SOUTHERN CALIFORNIA EDISON
KERN RIVER NO. 3 HYDROPROJECT

DOCKET NO. P-2290-122

**KERN RIVER BOATERS' COMMENTS AND STUDY
REQUESTS IN RESPONSE TO ISR SUPPLEMENTS**

KERN RIVER BOATERS' COMMENTS AND STUDY
REQUESTS IN RESPONSE TO ISR REPLIES

Figure 5.2-1. Unimpaired (sum of USGS gages 11185500 and 11186000) and Regulated (USGS gage 11186000) Median Monthly Flow in the North Fork Kern River, Water Years 1997–2019.

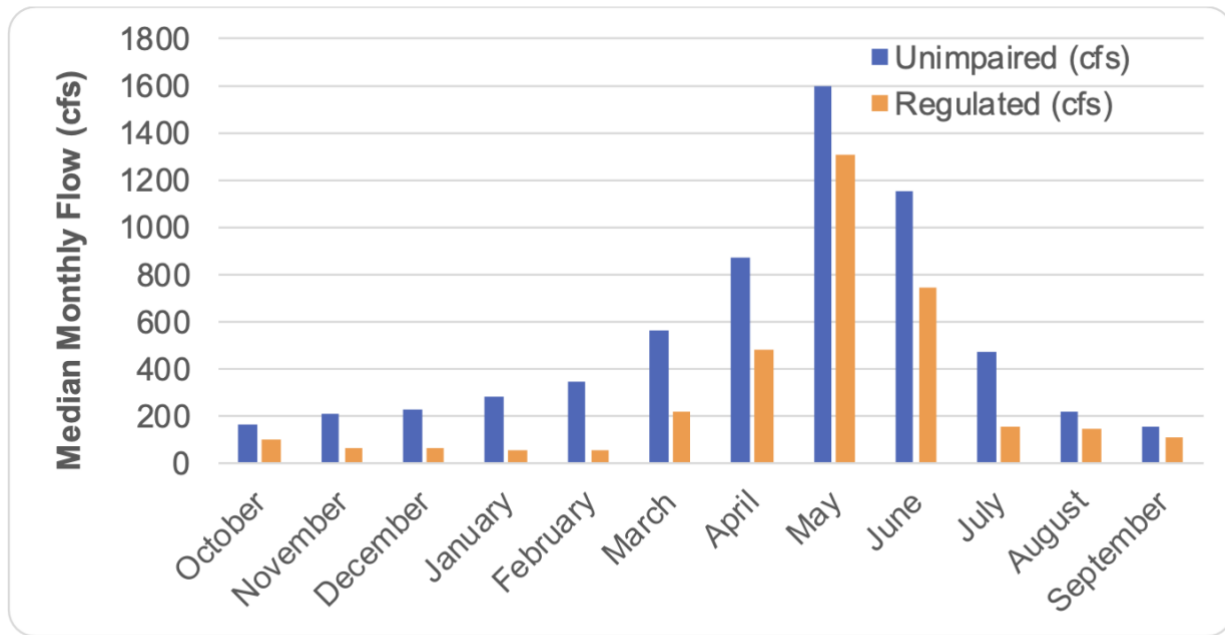
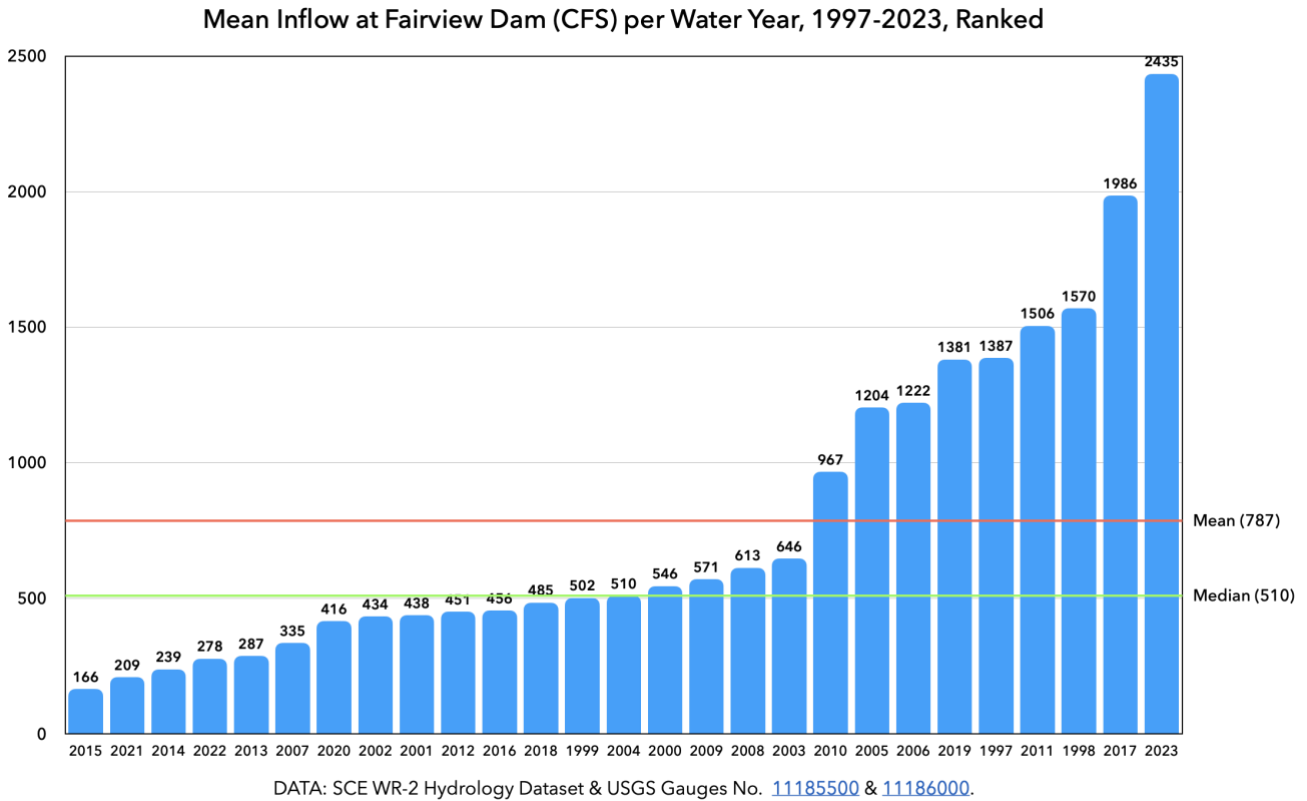
KRB: *If Edison’s assertion is true, it has completely failed to explain why it did not follow that assertion and instead employed the median rather than the mean as the statistical measure of monthly hydrological effects in the PAD:*

KRB freely acknowledges there are many proper uses of monthly means in river science — such as, potentially, characterizing flows in a single month from a single year, or flows over a set of years without meaningful outliers, or water volumes between water years. The key is whether the data set to be characterized is riddled with outliers. Here, the question is which statistical method best represents the monthly hydrological effects over this storageless, run-of-river diversion given the asymmetrical historical variations in snowpack and resultant flows above and below Fairview Dam.

Edison makes no effort to argue against our central analytical point: namely, that the median best represents the central tendency of an asymmetrical distribution. In the case of KR3, the data set is heavily skewed by the presence of outlier high water years. Applied to

Had Edison employed the mean as its monthly graphical representation in the PAD, we could have objected then, for the median is the best science in the context of KR3 hydrology. Edison’s change of methodology be should accordingly be deemed a variance — the median was implied by its prior usage and best science status — and the study should be modified to require graphical representations using the median, not the mean.

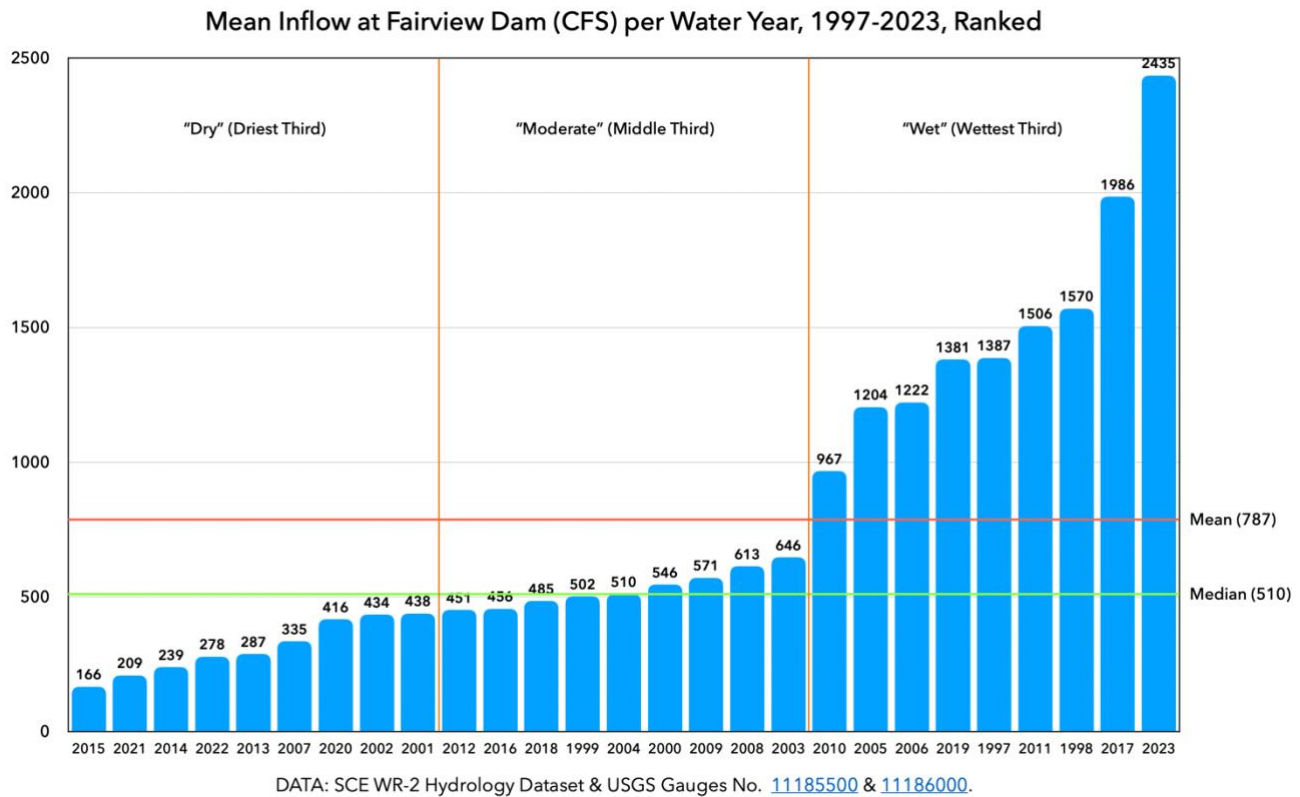
Nor does Edison contend that the distribution of water years on the NFKR is symmetric, for it cannot: just look at the values on the right side of the following chart¹:

Here is the same chart divided into thirds, representing Dry, Moderate, and Wet water year types²:

Consider what the chart shows: More than two-thirds the water years are below the mean, the mean is *more than 50%* higher than the median, and the maximum water year flow is *more than four times* greater than the median. The distribution of flows by water year in the NF Kern watershed is skewed heavily by the presence of outlier high water years. As a result, median values — as used by Edison in the PAD (and thus which we expected to be used in the ISR) — best represents the central tendency of KR3’s effect on this waterway.

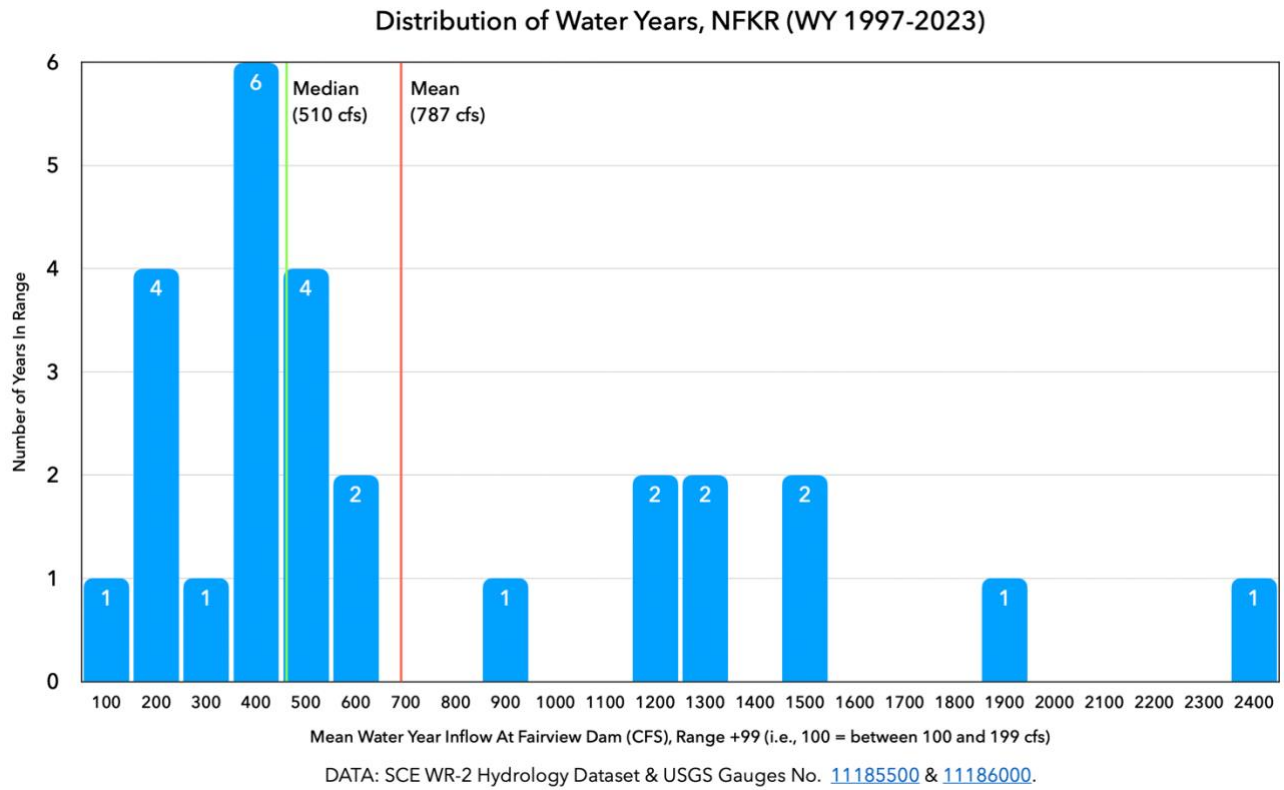
Edison offers no *reason* to dispute what we have argued, no reason to prefer the mean over the median here, and no example of any of the authorities it casually invokes actually using the mean over the median to represent an asymmetrical water year distribution at a storage-less run-of-river diversion. Those examples do not exist. As US Fish and Wildlife has explained: “What is the justification for using the median? The data are very variable and the median and mean are considerably different from each other. Because the median is a more robust measure of central tendency when outliers are present in a dataset, the median was used for all analyses in Appendix 3 rather than the mean.”³ Each of those elements is found here: outliers, large variation, and a mean which strays far afield of the median. Take another look at the histogram⁴ of water years on the NF Kern. It shows an

asymmetrical bunching of water years towards the left and a small handful of high-water years reaching out far, far to the right:

The central tendency of project effects in this watershed — *i.e.*, those effects most likely to be faced by the living things dependent on the quantity of water flowing below Fairview Dam — are best represented in monthly increments by the monthly median, not the monthly mean. Edison recognized this in the PAD and offered no reason to stray from it since.

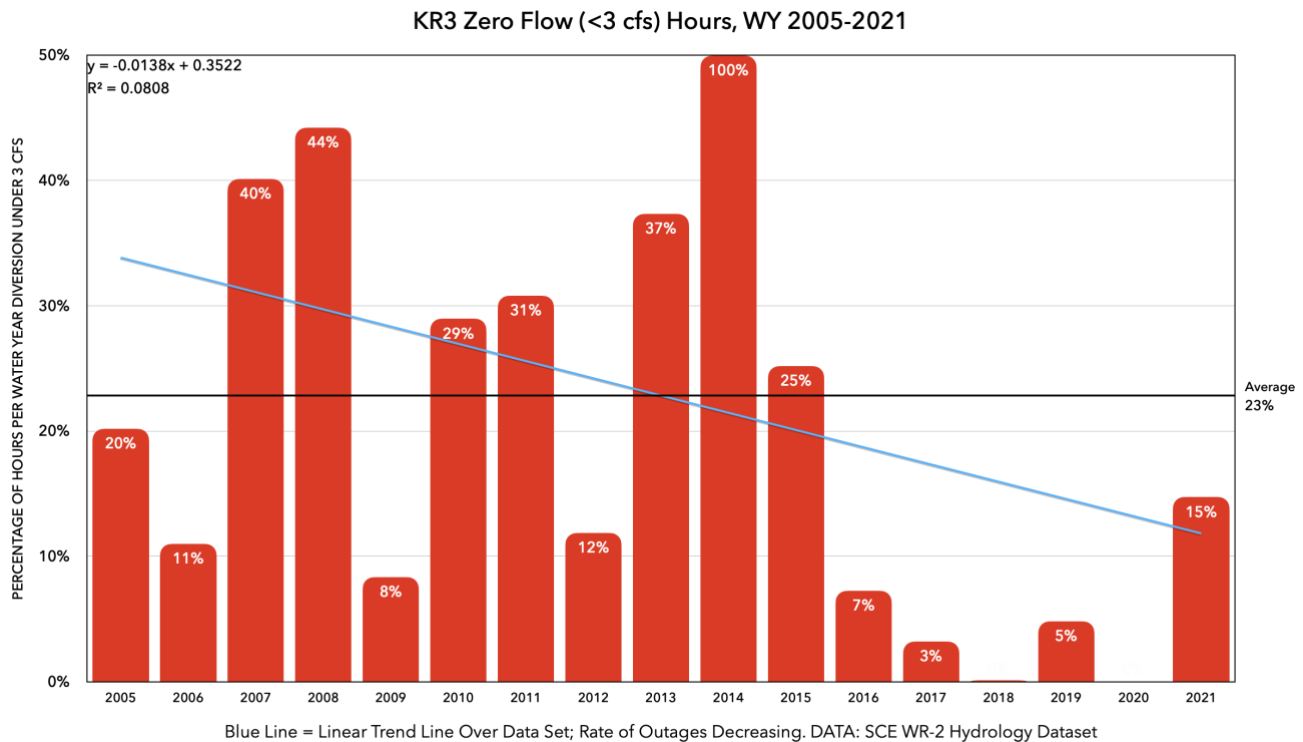
occur in the next license term — just look at the blue linear trendline over Edison’s hourly data set¹⁰:

So it is not true, as Edison urges, that “data collected and summarized under Study WR-2, along with other existing operational information will be sufficient to complete the analysis of effects and to develop license requirements.” (ISR Reply at 38.) To the contrary, with the past rate of outages so incredibly high — and with that rate decreasing over time after an intensive deployment of capital to improve project reliability — Edison’s current term hydrology *grossly understates* project effects going forward. Baseline “current conditions” include capital projects already completed to improve reliability. Current operations include those improvements, and past outages suffered to obtain greater current reliability should not improperly influence the analysis of baseline project effects going forward.

only 28 (see Table 4.6-2 at PAD 4-25)— less than 10% of all months in the data set. Ten percent is a far, far cry from the 23% figure that Edison revealed post-PAD in the hydrology dataset. If Edison had been upfront with that figure — and the recent reduction in rate of that figure — interested managing agents could have asked for an authorized flows hydrology as well. We ask that the authorized flows study be performed in line as described in our ISR request.

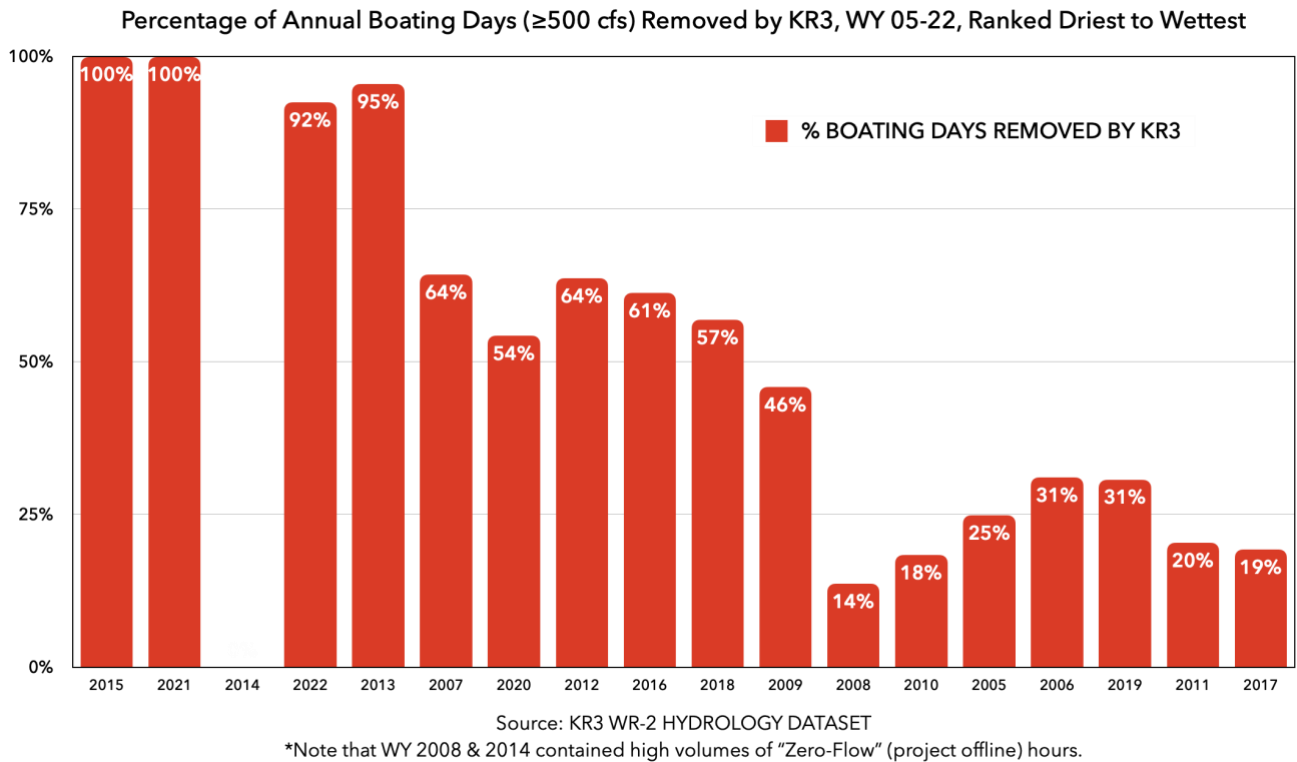
This is an important issue. It is in Edison’s interest to keep the definition of a “boating day” at a higher level rather than a lower one: project effects in removing boating days *increase dramatically* as the flow definition of a boating day *decreases*. Consider WY 2022, whose hourly data was recently released by Edison. In that year, the project removed 14 of 17 “boating days” at 700 cfs, but 49 of 53 boating days defined at 500 cfs²²:

We again ask that the Commission direct Edison to modify the ISR and the remaining REC-1 study to require graphical summaries based on an accurate flow definition of a boating day, account for project effects in dry and moderate water years, and account for the time the project was offline.

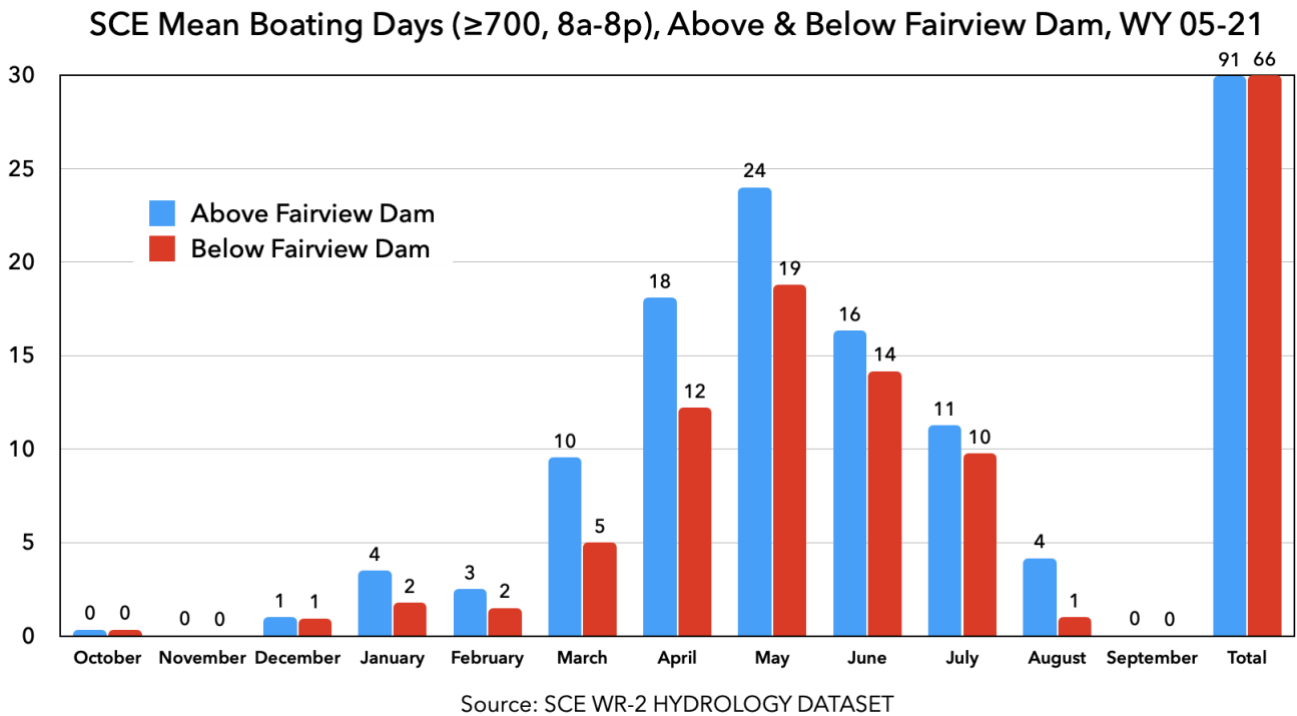
Edison also fails to account for the fact that project effects on boating are felt more strongly in dry years than wet: In dry years, the project takes away almost every boating day, in moderate years about half, and only a quarter in wet years²³:

Finally, as we discussed in our initial comments, Edison’s boating days analysis fails to inform its readers that the project was offline 23% of the time during its data set. For these reasons, Edison’s current boating days analysis in the ISR is extremely inaccurate and misleading in its favor — consequences that cannot reasonably coexist with the approved study.

KRB Median Boating Days (≥ 700 , 8a-8p), Above & Below Fairview Dam, WY 05-22

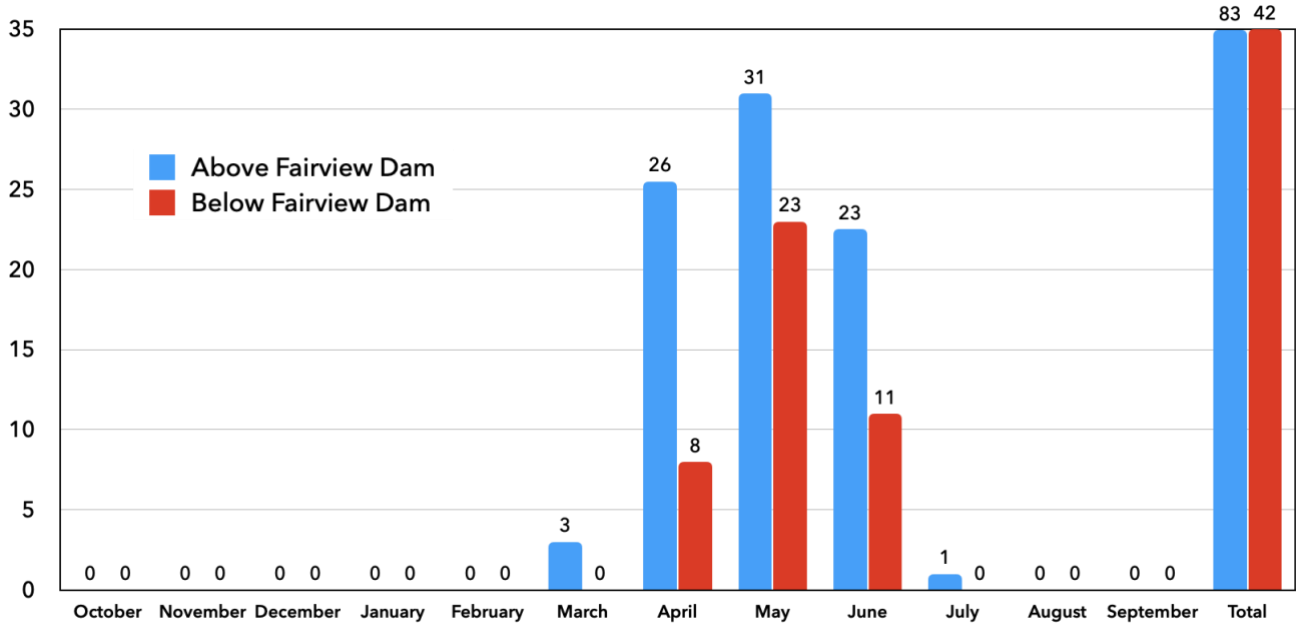
KRB: We fail to see how this response invalidates our comment. If the median will be included in the USR, why was it not used in ISR, where first impressions on study data are made? We have shown the distribution of water years in the NF Kern watershed is not of a symmetrical nature suited to analysis by the mean. Rather, it is asymmetrical, skewed by outlier high water years up to four times greater in water volume than the median that push the mean almost 50% higher than the median. The central tendency of such a system is inarguably represented best by the median. Again, a comparison of *median* monthly boating days above and below Fairview Dam paints a much different picture of project effects than Edison’s ISR REC-1 Figure 5.1-9 — what follows is a look at the mean, then the median²⁴:

Wet years add undue, large numbers of available boating days to the average because the project is capped at removing 600 cfs from the river. Those figures are undue since wet years are infrequent and accordingly should not be afforded inordinate weight by padding the stats, so to speak, in favor of Edison. The more typical project effect confronting boaters is best represented by the median. The REC-1 ISR “mean monthly boating days” summary is accordingly at variance with the approved study and should be corrected.

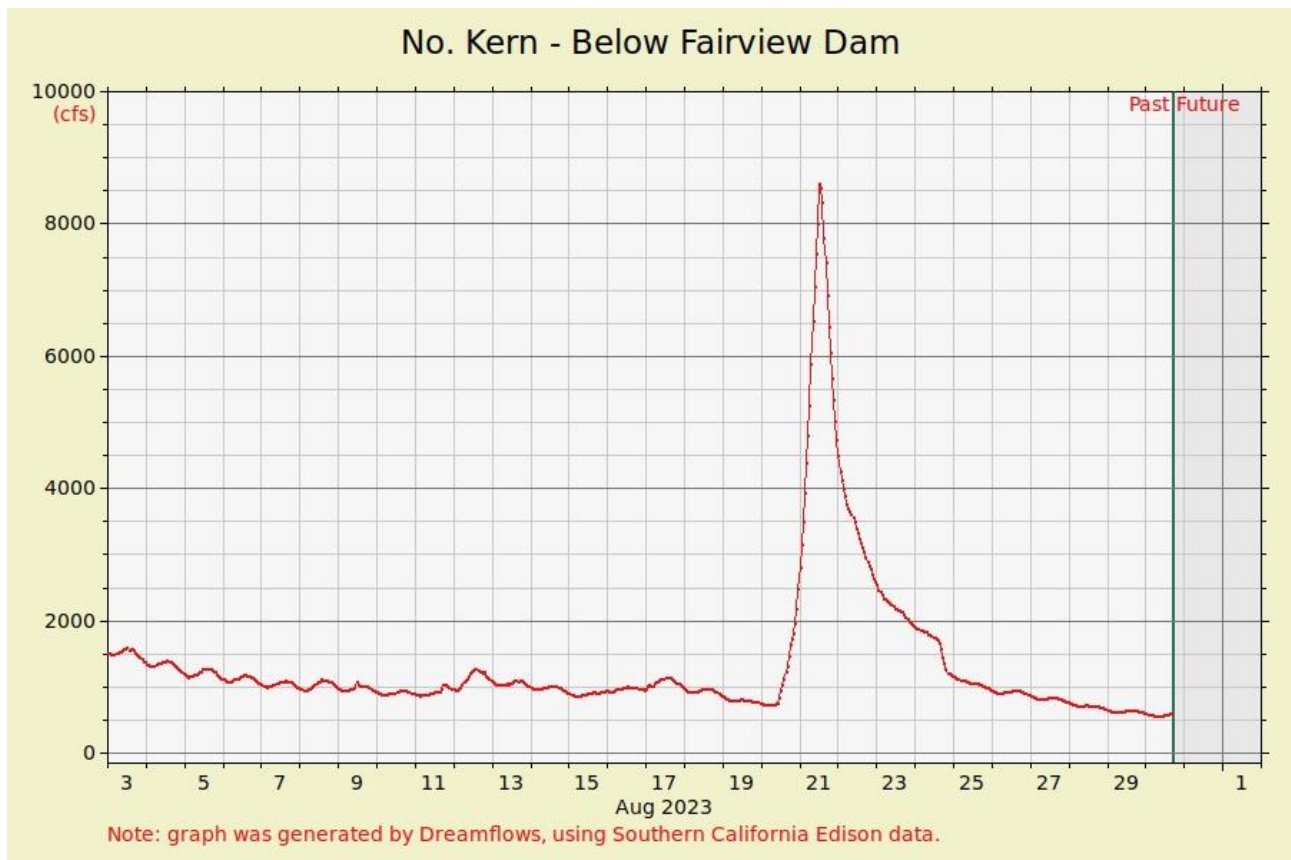
KRB: Edison’s assertion that results would not be substantially different is conjecture and offered with neither evidence nor analysis. It is uncontroversial that the project’s peak effects on recreation are seen near or at the MIF. Last year — the highest water year by far over the current license term — the diversion at Fairview Dam did not drop flows below it to MIF levels until the last half of September. That is wholly unlike median years where fish flows set in by early July, and low water years where they set in early June. Campers, hikers, sightseers, angler, and boaters are thus *typically* confronted with flows near the MIF (130 cfs + buffer) for most or all of the summer. That was far from the case during last year’s anomalously high snowpack and lengthy runoff season. To take but one example, flows below Fairview Dam are typically around 150 cfs in August but remained well over 500 cfs that month last year:
